Ref: **Subsidence Damage due to Tree Root Nuisance**  
Loss at: [REDACTED] Cambridge, [REDACTED]  
Insured: [REDACTED]

## Monitoring Report

# Update Following Completion of Site Investigations

Results of: precise levelling . crack monitoring . distortion survey . verticality monitoring

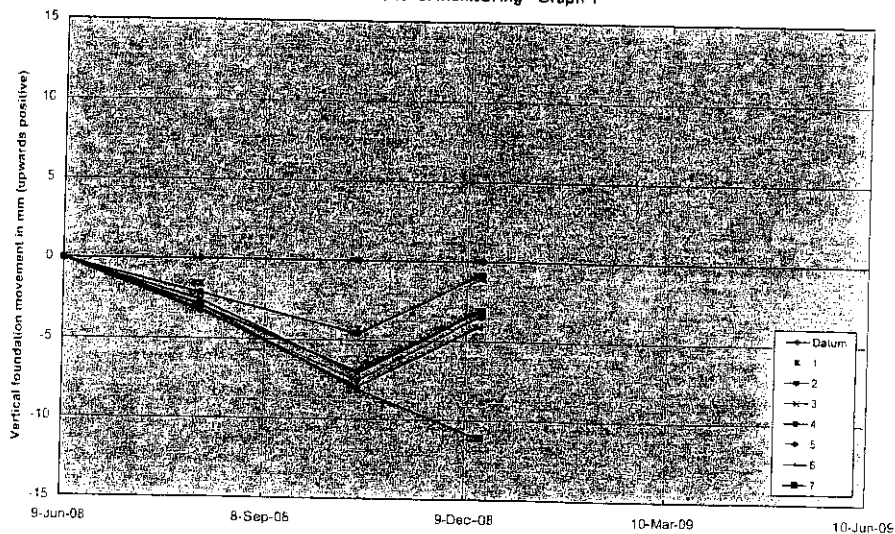
3. You have partially commented on the 'rate and pattern of movement' as determined by the precision level monitoring. Is the degree of movement at the individual monitoring stations consistent with the plane being an effective and substantive cause i.e. I would have expected the greatest movement at the monitoring stations closest to the subject tree. If this is not the case is there another plausible explanation?

The readings show that the property is experiencing differential seasonal movement and that the seasonal movement is most severe to the left hand side of the house. The most severe movement has occurred at points 9, 10 and 21 where the downwards movement has been in excess of 10mm. These points are concentrated to the rear left hand corner of the house and the front corner of the garage. This compares with downwards movement of less than 5mm affecting the front right hand corner of the house (point 1). The December readings show that the house has now recovered substantially.
